ARCHITECT'S SUPPLEMENTAL INSTRUCTIONS

PROJECT:	The Residence at Green Meadow New Senior Development San Angelo, TX	Report No.	One (1)
OWNER:	Overland Property Group Dan Maximuk 234 N. Santa Fe Ave, Suite A Salina, KS 67401	Date	Dec. 18, 2024
CONTRACTOR:	MCP Group 3501 SW Fairlawn Rd. Topeka, KS 66614	Architect's Proj No.	24-3395
		Contract For:	General Construction Mechanical, Electrical

A ROOF PLAN
1/8\"/>

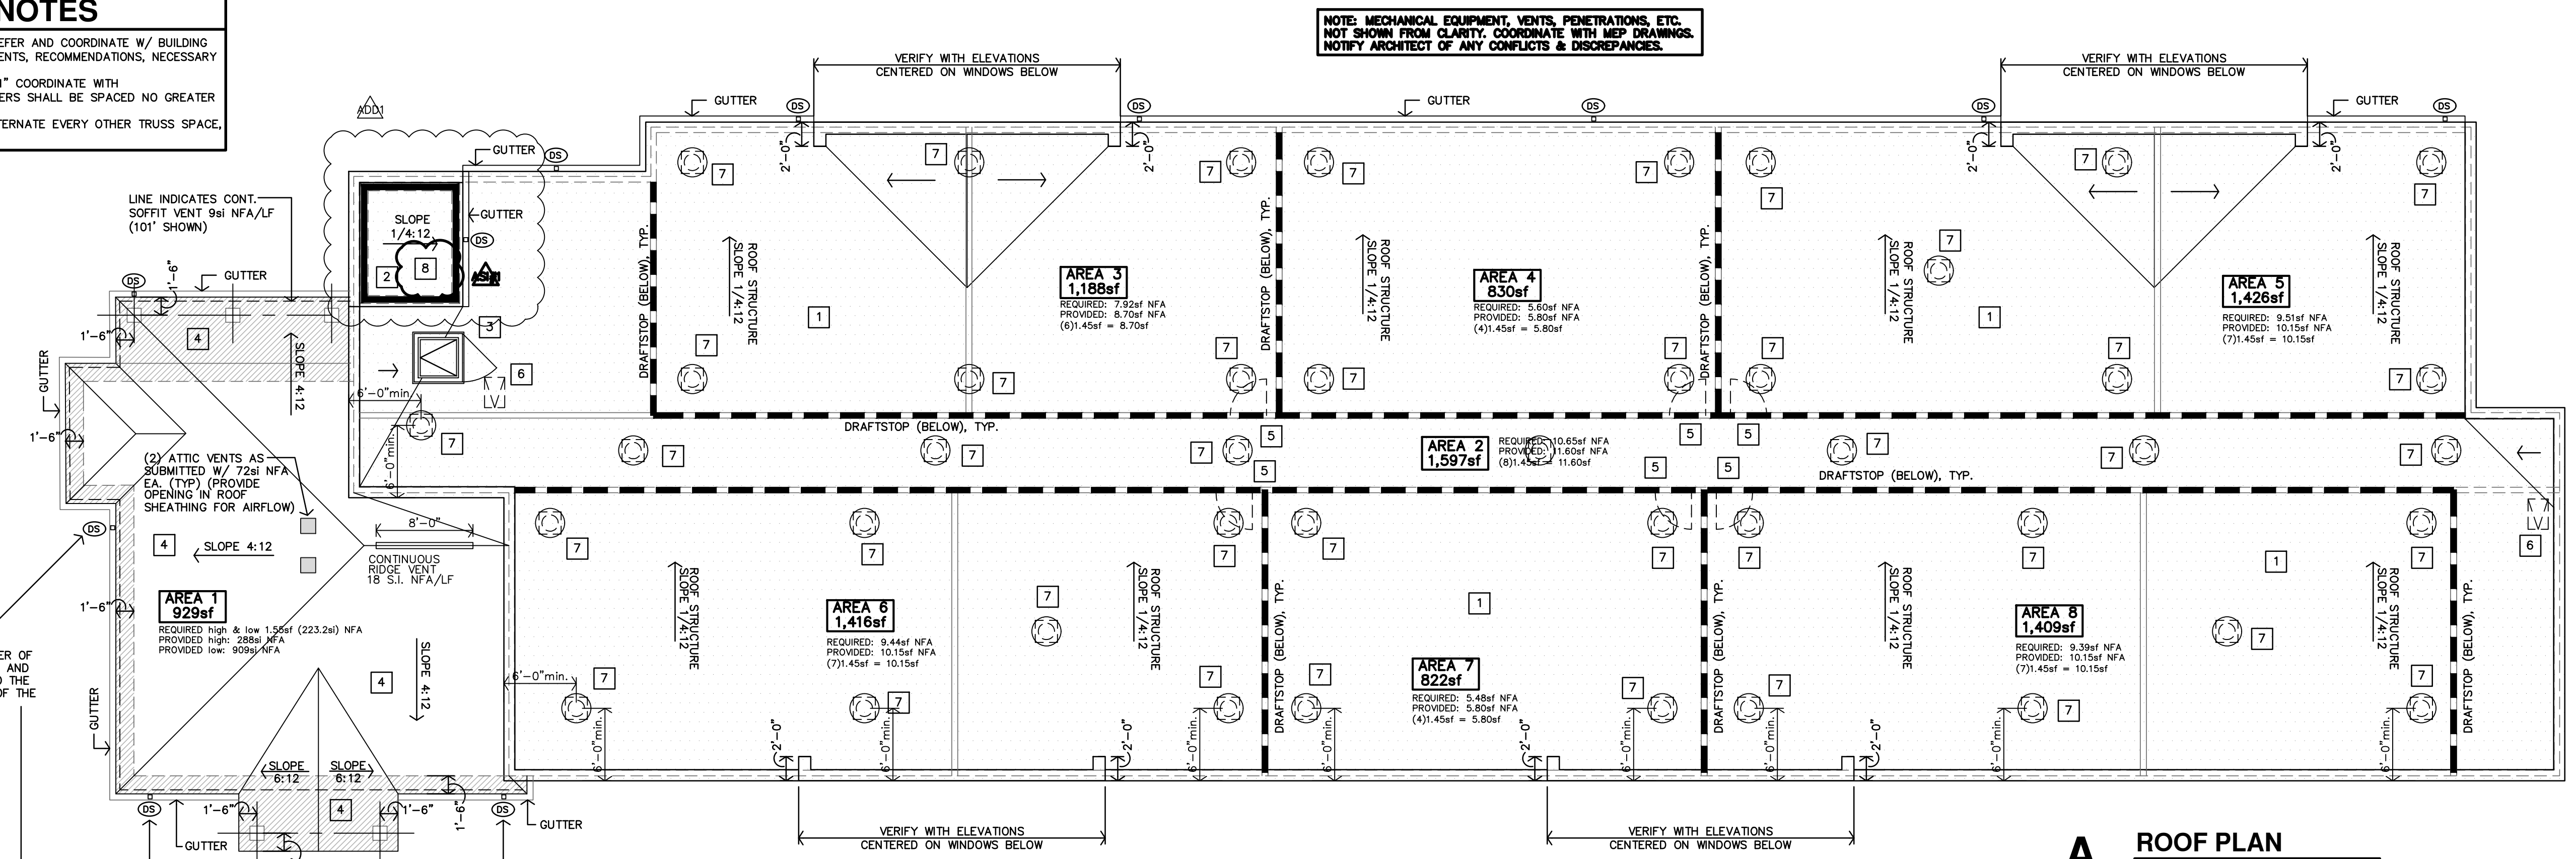
- 10) Sheet A5.1 – revised note 1, and added note 8 (roof at elevator shaft). No XPS insulation needed at main roof. XPS insulation (6" min) required at roof above elevator shaft.

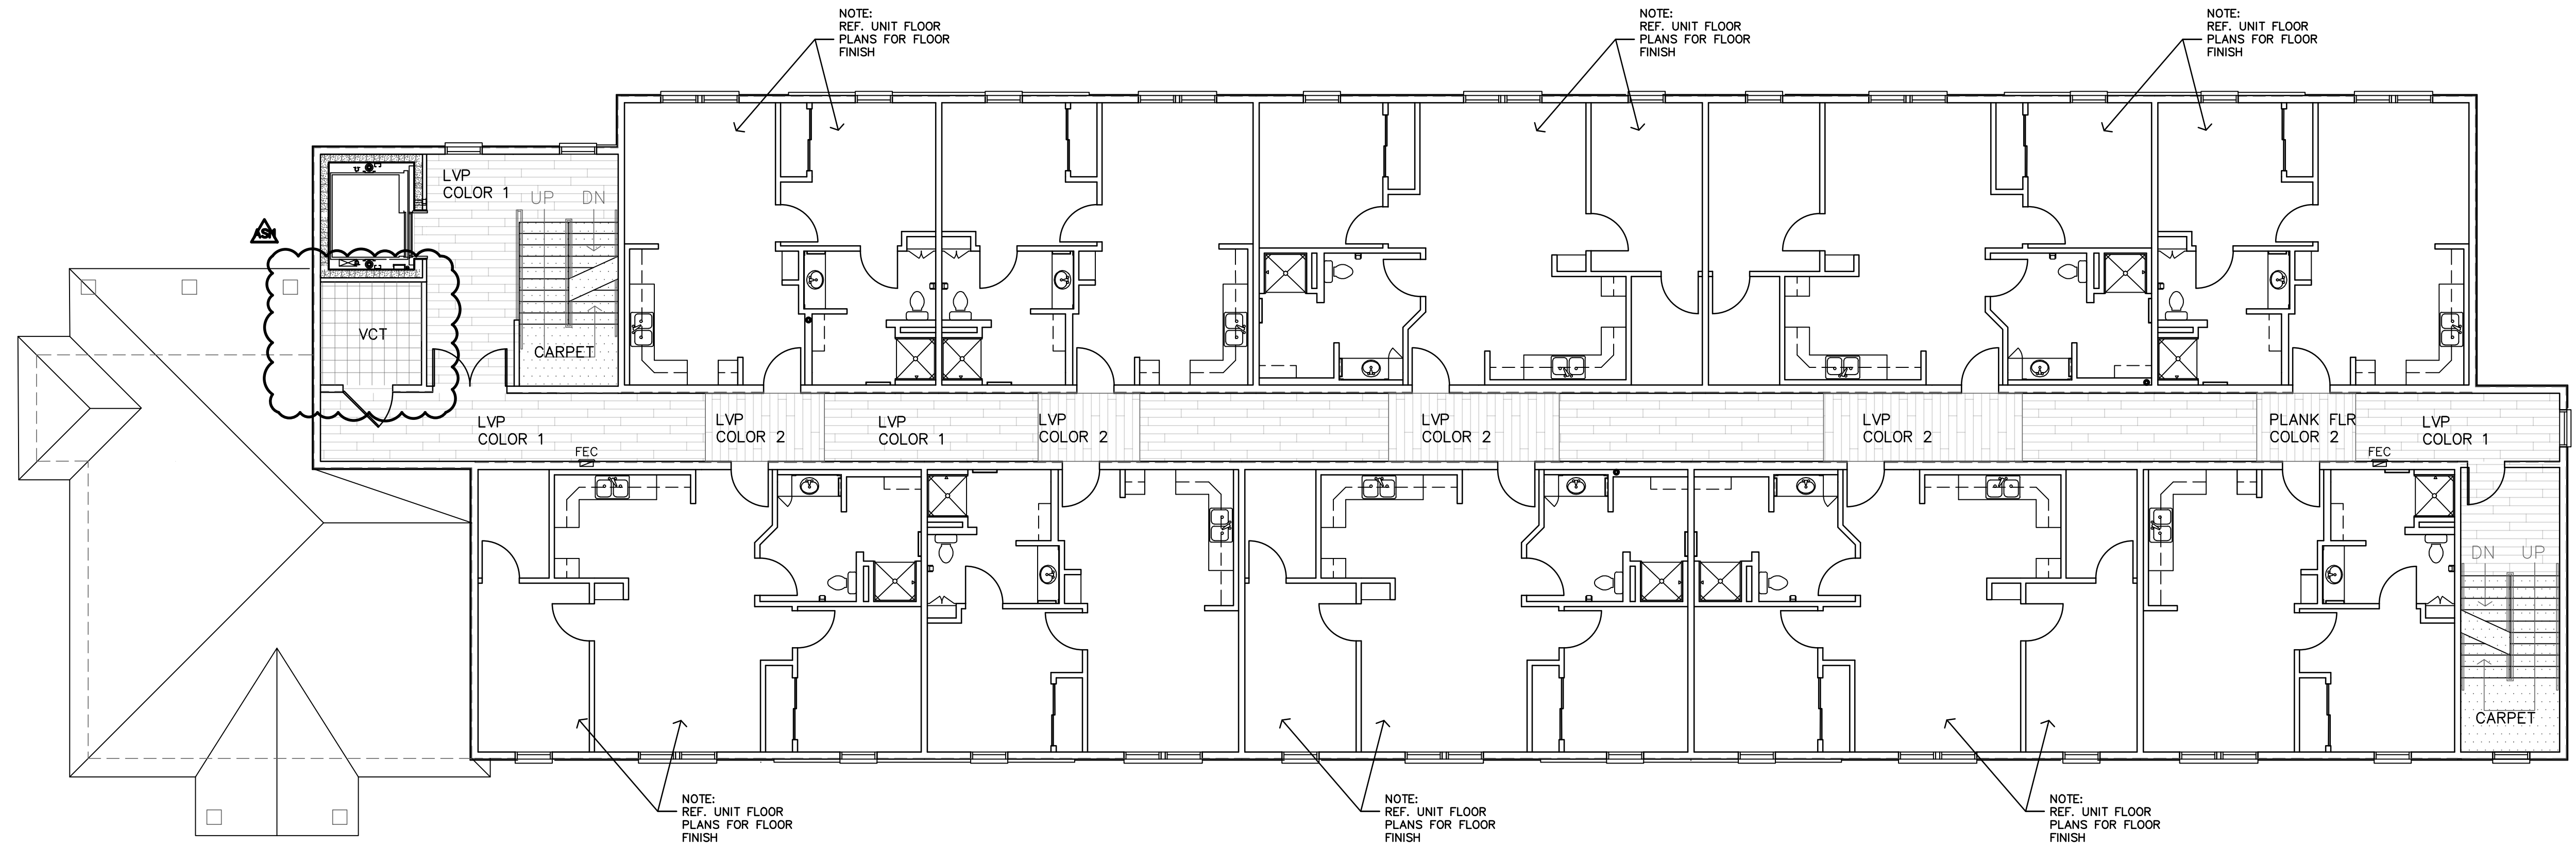
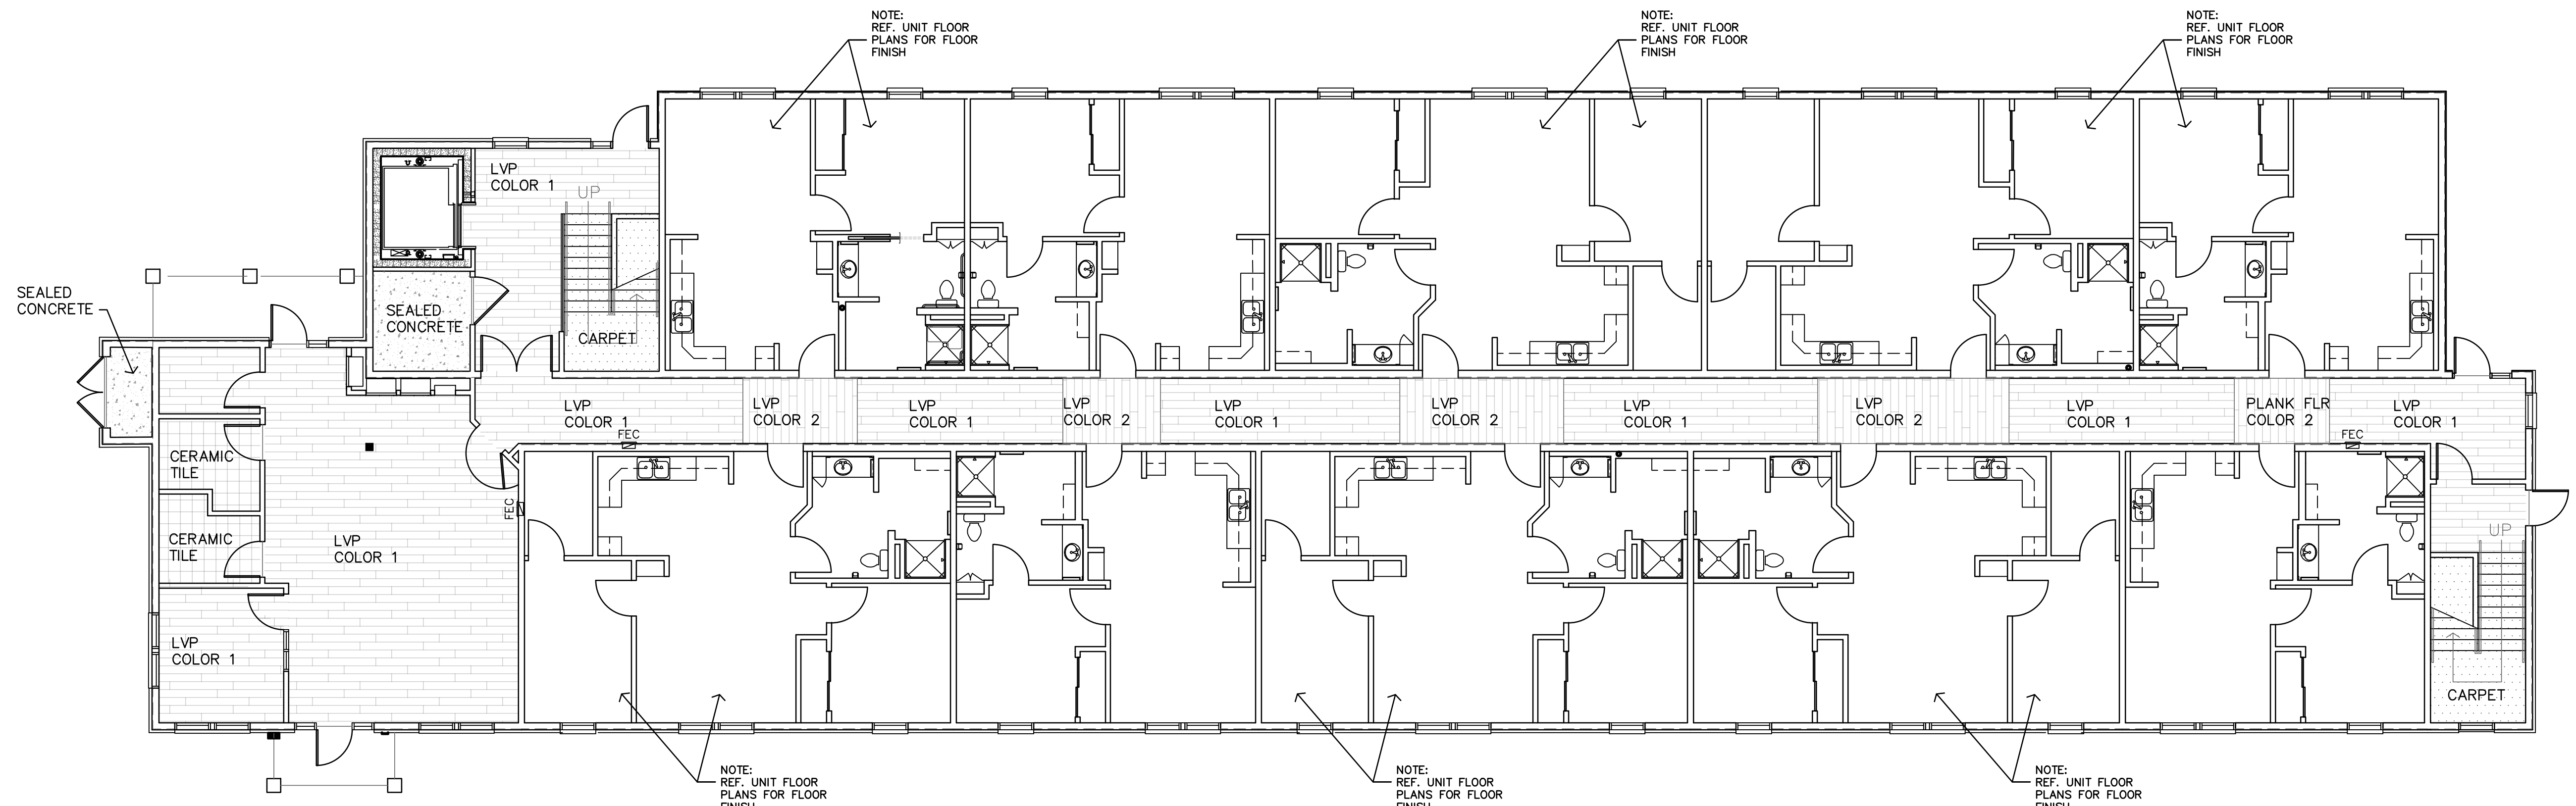
- 12) Sheet A9.1 – Floor finish at Mech Closets 201 and 301 has been changed to VCT in lieu of sealed concrete.
- 13) Sheet A10.1
 - a. Window Schedule – notes 5 and 6 have been revised to reflect the 2021 IBC designations & section call-outs.
